# TECHNICAL BULLETIN

Date: 3/31/08  
Engineer: Larry Cuccio  
Page: 1 of 5

To: Distribution  
Product: SE-79HD System Expander  
Symptom: Loss of vertical sync in video in the LCD Viewfinder

FIG. 7

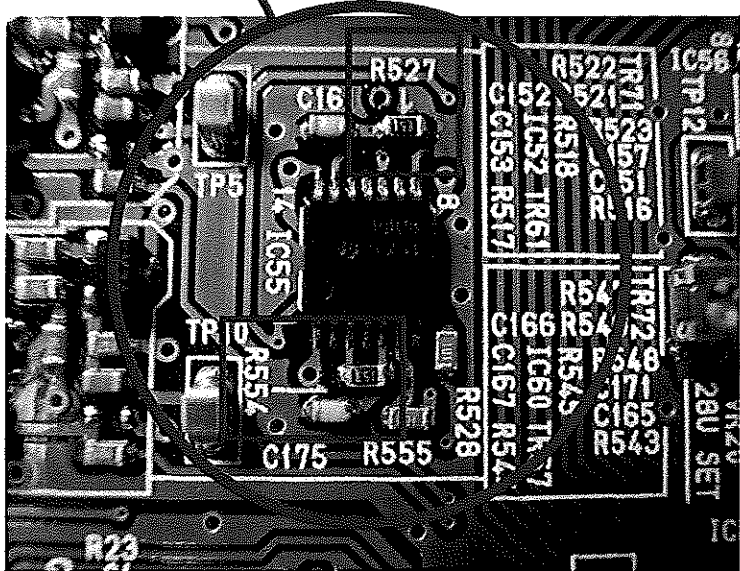
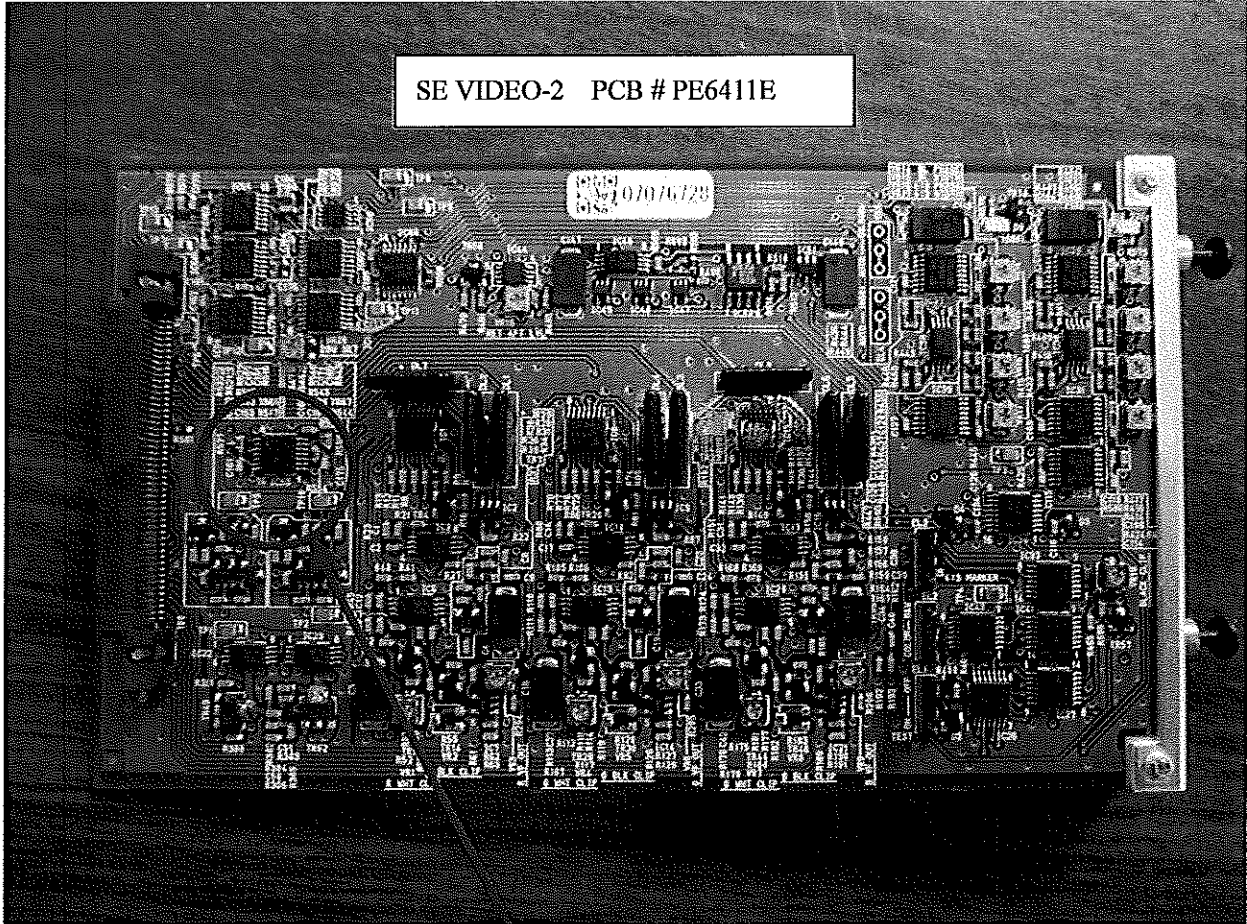
1. Remove the video board. It is located in the rear of the system expander, on the left side behind the panel with the VF aspect control and tally light. Loosen three screws to remove this panel. ( Refer to Fig. 1, control location 12, for panel location ).
2. Remove resistors R527 and R554. Refer to Fig. 2 for their location.
3. Replace with 15K ohm resistors.

Fig 2

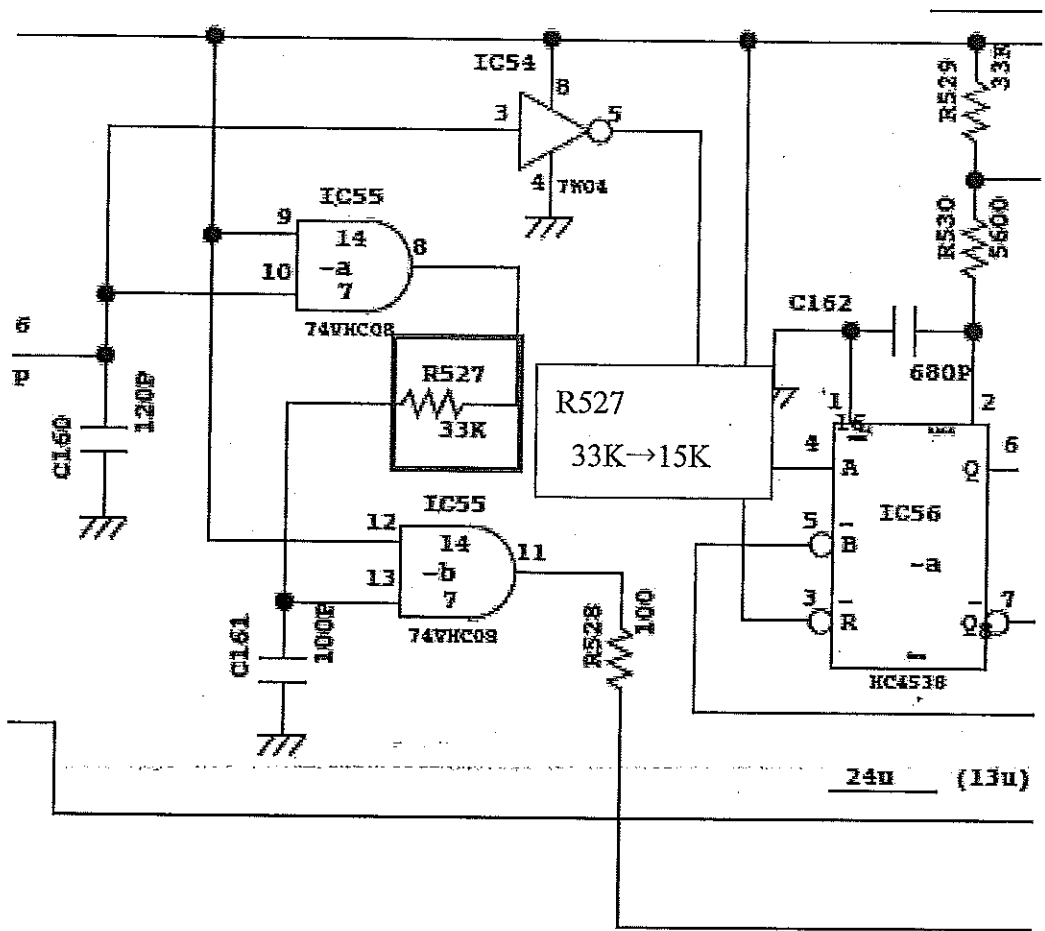
To upgrade the SE-79D System Expander to accept all formats, a new multi-format Video Board is installed. Occasionally, a problem can occur where vertical sync is lost in the VF video, resulting in an unstable, rolling image. This problem occurs only in the multi-format video board with PCB # PE6411E. To correct this problem, two resistors, R527 (33K ohm) and R554 (33K ohm) will need to be changed to 15K ohm values.

Resistor, 15K ohm, P/N RGC1/16C 153D
